# Access Compliance Report

## Public Rights-of-Way

### (Curb Ramps)

Intersection ID: 7953	Main Street: MARIETTA_ST	Cross Street: DAVID_AV	Location:	E
ADA ID: 560F38634413	Ramp Type: Perp	Initial Pass/Fail: Fail	Overall Compliance: No	Severity Score: 8.75
Codes/Mitigation Info/Possible Solution		Field Measurements/Component Compliance

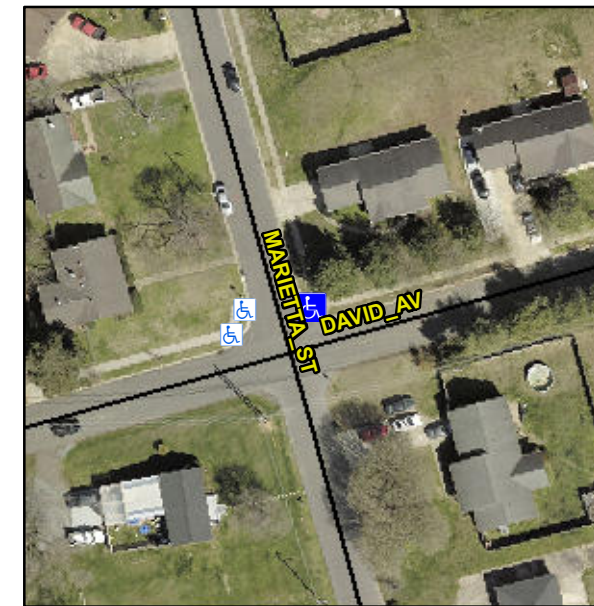
**R304.5.1**

Compliance	Description	Data	Compliance	Description	Data
N/A	Ramp Length (in)	48.0	Yes	Ramp Slope (%)	5.0
No	Ramp Width (in)	38.0	Yes	Ramp XSlope (%)	1.6
N/A	Flare Type LT	N/A	N/A	Flare Type RT	N/A
N/A	Flare Slope LT (%)	N/A	N/A	Flare Slope RT (%)	N/A
N/A	Flare Traversable LT?	N/A	N/A	Flare Traversable RT?	N/A
N/A	Landing Length (in)	N/A	N/A	DWS Provided?	N/A
N/A	Landing Width (in)	N/A	N/A	DWS Contrast?	N/A
N/A	Landing Slope (%)	N/A	N/A	DWS Length (in)	N/A
N/A	Landing X Slope (%)	N/A	N/A	DWS Full Width?	N/A
N/A	Landing Curb? (Y/N)	N/A	N/A	DWS Offset (in)	N/A
N/A	Shared Landing?	N/A			
N/A	Gutter Ponding?	N/A	N/A	Gutter Slope (%)	N/A
N/A	Gutter Lip Ht (in)	N/A	N/A	Gutter X Slope (%)	N/A
N/A	Painted X Walk1?	No	N/A	Painted X Walk2?	N/A
	X Walk 1 Direction	To W		X Walk 2 Direction	N/A
N/A	X Walk 1 Width (in)	N/A	N/A	X Walk 2 Width (in)	N/A
	X Walk 1 Slope (%)	1.5		X Walk 2 Slope (%)	N/A
	X Walk 1 X Slope (%)	2.9		X Walk 2 X Slope (%)	N/A

**Remove & Replace Entire Ramp.**
